From: [Joel Geier](#)
To: [Coffin Butte Landfill Appeals](#)
Subject: LU-24-027 testimony
Date: Tuesday, October 7, 2025 4:51:28 PM
Attachments: [Hydro Comments Joel Geier 2025-10-07.pdf](#)

2) Brief comments on applicant's new claims in their Exhibit 67

Annex 1: Detailed information regarding groundwater issues

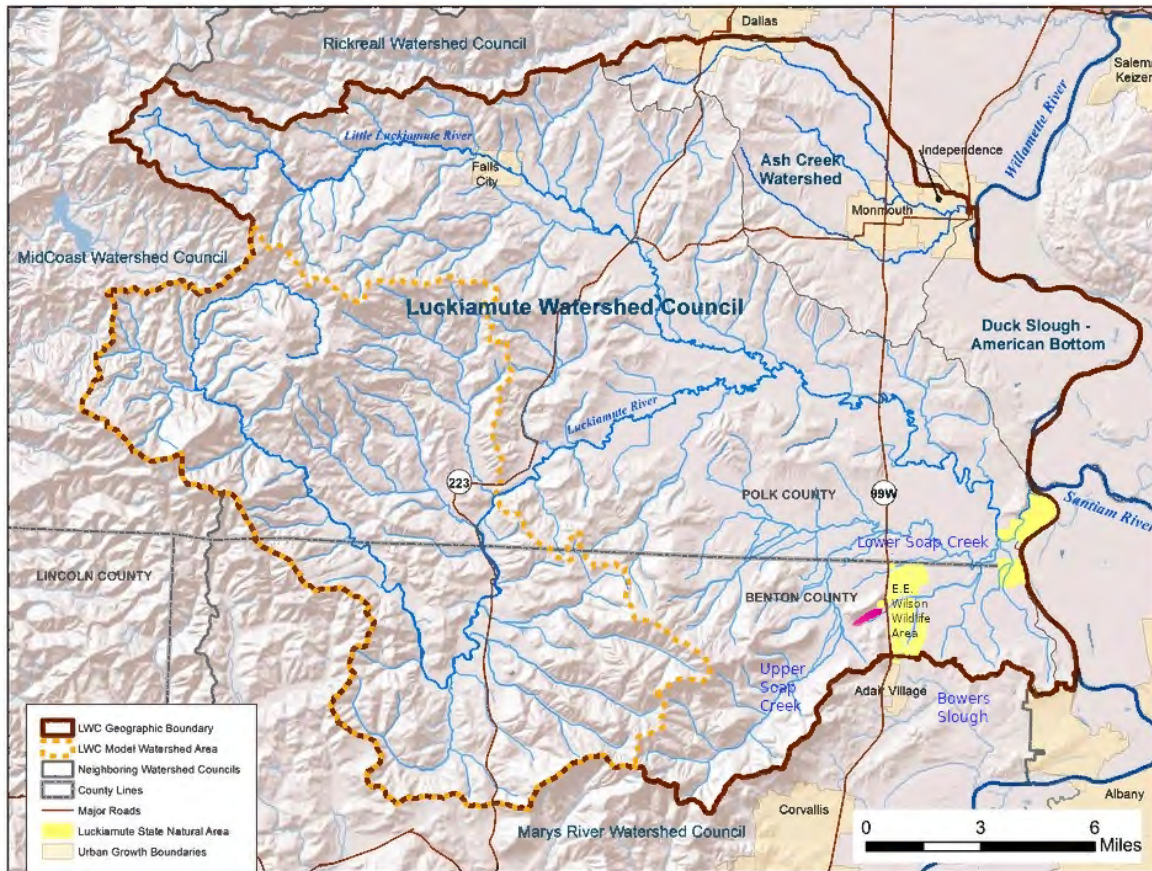
In fact surface drainage from the landfill complex flows both eastward and westward, because the landfill is located in a topographic saddle between Coffin Butte and Tampico Ridge. Drainage from portions of the landfill complex on the east side of the saddle does flow out onto E.E. Wilson Wildlife Area, but onto the portion that belongs to the Luckiamute River Watershed. Only a few acres of E.E. Wilson Wildlife Area, namely wetlands in the far south end adjacent to Adair Village, drain toward Bowers Slough, but those are on the other side of the surface water divide from Coffin Butte (Figure 1).

Figure 3. Arsenic and chloride levels in compliance-boundary wells MW-26 and MW-27 as plotted by VLI's consultants in Exhibit 49. Note that chloride is plotted in milligrams per liter (parts per million) while arsenic is plotted in micrograms per liter (parts per billion).

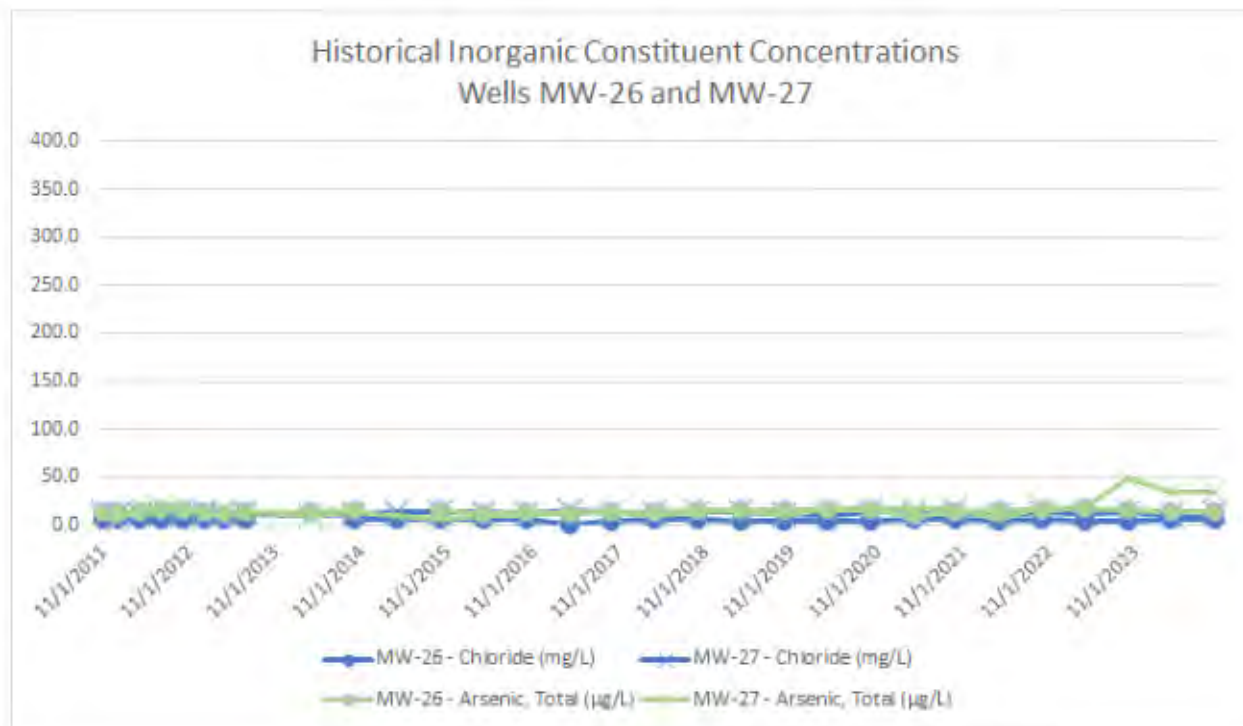
VLI's presentation of data from monitoring wells at Coffin Butte is also misleading. In presenting historical data on arsenic at Coffin Butte, they misleadingly plot data on a strangely chosen scale, with a maximum 10 times the range of the data (Figure 3). The effect is to conceal the strong fluctuations over time which are evident in a more scientifically reasonable presentation of the same data, as used in their Annual Environmental Monitoring Reports (Figure 4).

Note that the first plot in Exhibit 49 shows no arsenic measurements above 50 micrograms per liter ($\mu\text{g/L}$), but values up to 68 $\mu\text{g/L}$ have been measured in a nearby well more recently. VLI's consultants are certainly aware of those recent high values.

Figure 5. Arsenic and chloride levels in MW-9S as plotted by VLI's consultants in Exhibit 49.

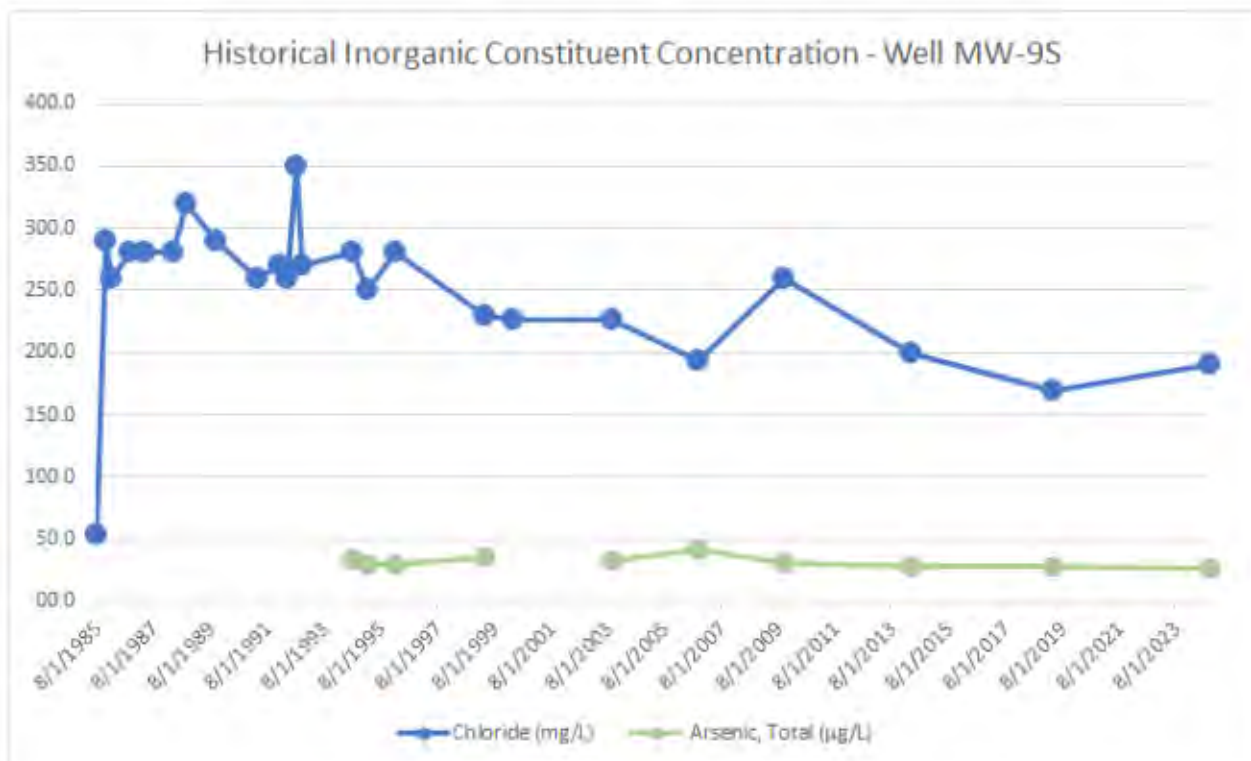
In the applicant's attempt to defray concerns about arsenic, they suggest that chloride is a better indicator. The second plot in Exhibit 49 (reproduced here as Figure 5) shows that the initial measurement of chloride in MW-9S was about 50 mg/L, but soon afterward the concentration jumped by nearly a factor of 6.

Though this declined somewhat after the seepage problem was discovered in the mid-1990s, and corrective actions were taken, chloride in MW-9S has remained more than a factor of 3 above the initial baseline value, ever since. Far from alleviating concerns about leakage from Cell 2, this plot elevates concerns about potential for ongoing contamination of the Willamette Basin aquifer.

Figure 6. Schematic illustration of a narrow leachate plume originating from a liner leak, depicting how this may result in the plume bypassing monitoring wells that are located close to the landfill (Cherry, 1990).

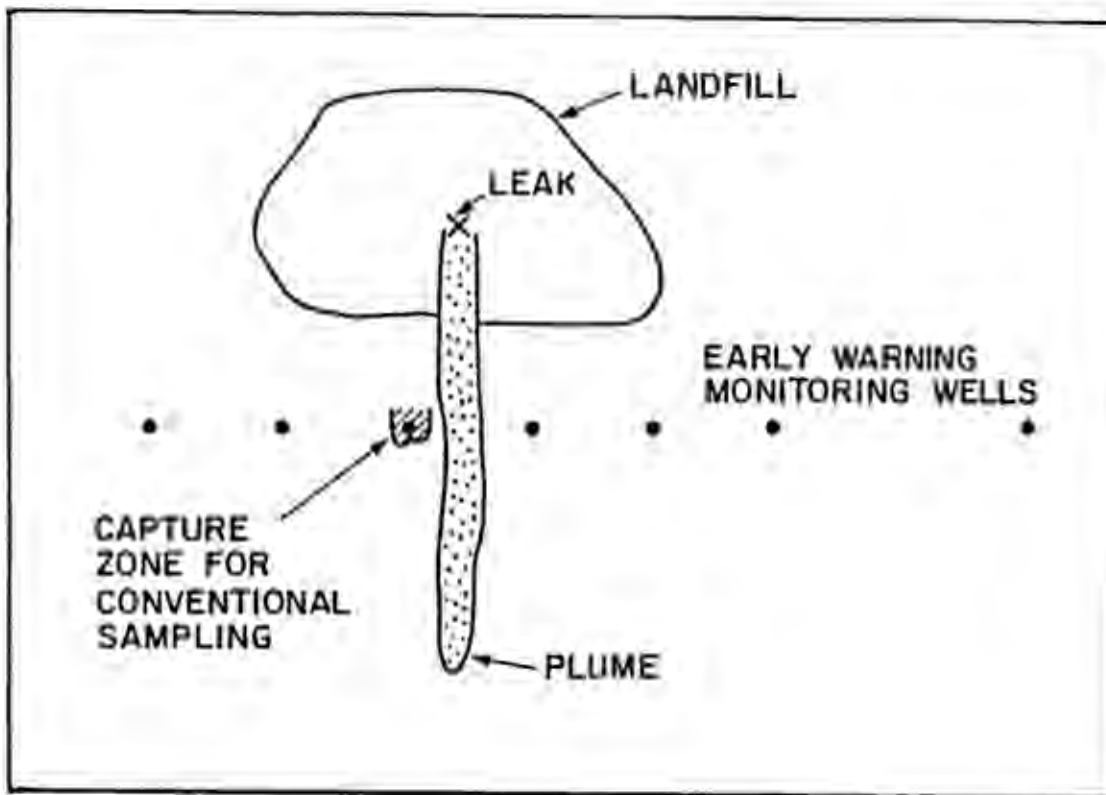
As discussed by Cherry (1990), plumes from a localized leak in a landfill liner could be narrow due to weak lateral dispersion (Figure 6); Cherry noted that this problem is especially acute for monitoring wells located close to the landfill, which is currently the situation for MW-26 and MW-27. Since the conditions controlling flow from underneath a landfill may change over time as various cells are developed, the groundwater flow direction and position of the leachate plume can also shift over time.

As noted above, and discussed further by Cherry (1990), sentinel wells located close to the edge of a landfill might not be effective for detecting leachate plumes that originate from narrow liner leaks.
